DR-2017-001; VR-2017-007

**Downtown Design Review; Variance
2036 SE Washington St**

Planning Commission

August 22, 2017

Figure 19.304.5.B.2
Building Height Standards

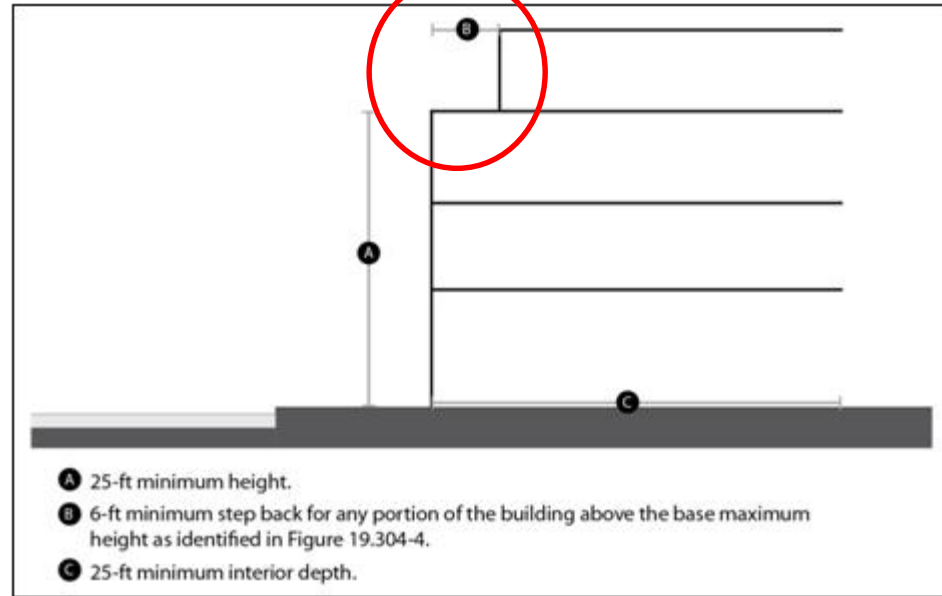
- Voted 3-0 to recommend approval of the 6-ft step variance as follows:
 - Require a min. 4-ft step back on the 5th floor on the 21st Ave and Washington St facades

- Is the requested variance to the 6-ft step back requirement reasonable?

Key Questions - #3

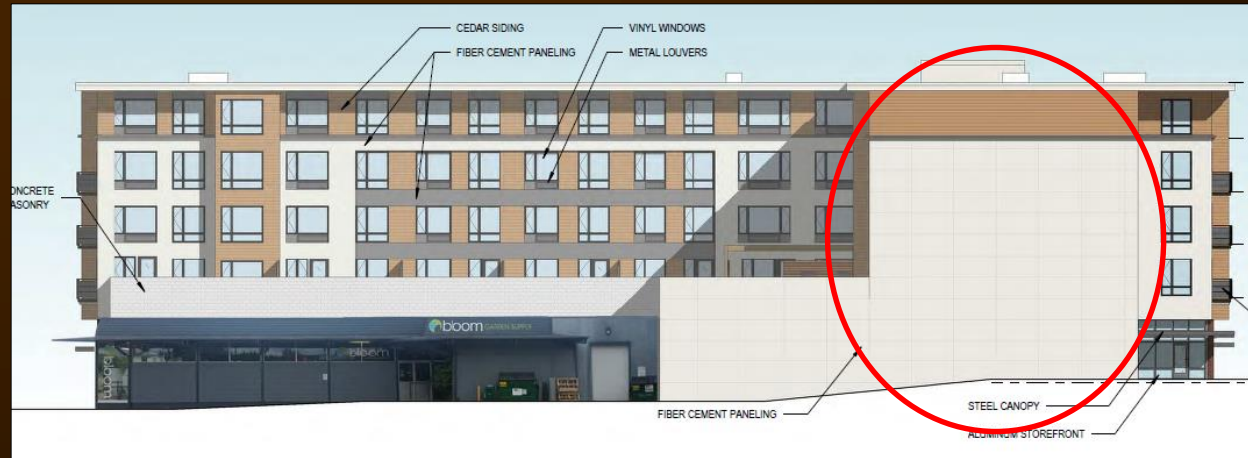
- Should the proposed design address the blank wall facing Adams Street Connector? If so, how?
